CNL-16-201

Clinch River Nuclear Site
NRC Project No. 785

Subject: Submittal of Supplemental Information Regarding Aquatic Ecology in Support of Early Site Permit Application for Clinch River Nuclear Site

Supplemental Information Regarding Aquatic Ecology

Figure 1. Watts Bar Reservoir Ecological Health Ratings, 1994-2014

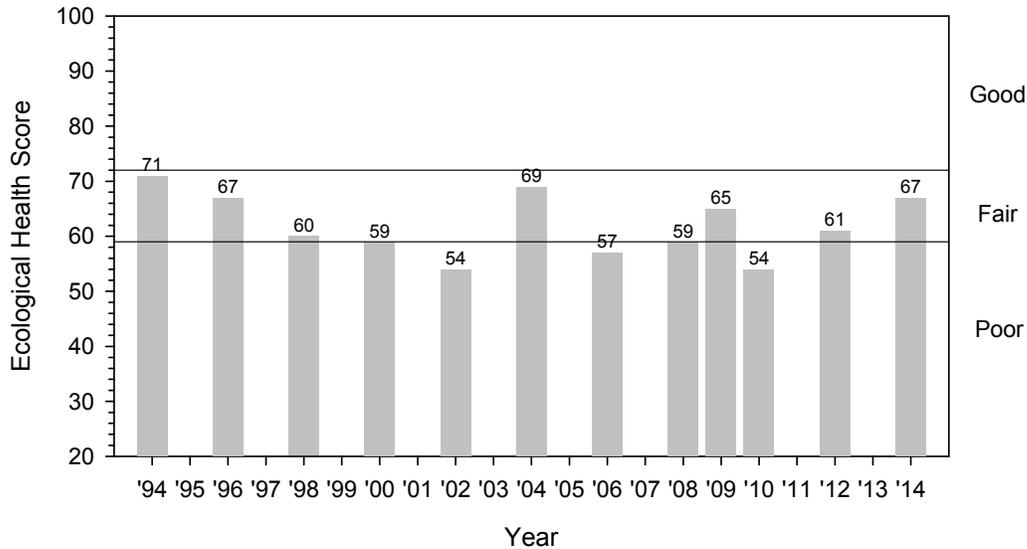
During interactions with the NRC staff, it was identified that some of the sampling data used to evaluate the ecological health of the Clinch River is over five years old. Therefore, TVA is providing justification for the relevance of the sampling data with regard to the current ecological health of the Clinch River.

The ecological health of Watts Bar Reservoir has been monitored using the same methodology since 1994. Reservoir ecological health evaluations focus on five indicators: dissolved oxygen, chlorophyll, sediment quality, benthic macroinvertebrate community (bottom life), and fish assemblage. TVA monitors four locations on Watts Bar Reservoir: the deep, still water near the dam, called the forebay (Tennessee River Mile [TRM] 532.5); the middle part of the reservoir (TRM 560.8); and the river-like areas at the extreme upper end of the reservoir in the Tennessee and Clinch Rivers, called inflows (usually on a 2-year cycle). The Clinch River monitoring location is at Clinch River Mile (CRM) 22.0, which is just upstream of the CRN Site. This long-term monitoring approach gives a continuum of data over a long period of time. The Watts Bar Reservoir is sampled every two years, with the last sample collected in 2014. The next collection is scheduled for fall 2016. The overall ecological health condition for the Watts Bar Reservoir rated fair in 2014. As shown in Figure 1, ecological health scores for the Watts Bar Reservoir have fluctuated between "high fair" and "poor" for over two decades, and have generally followed reservoir flow conditions.
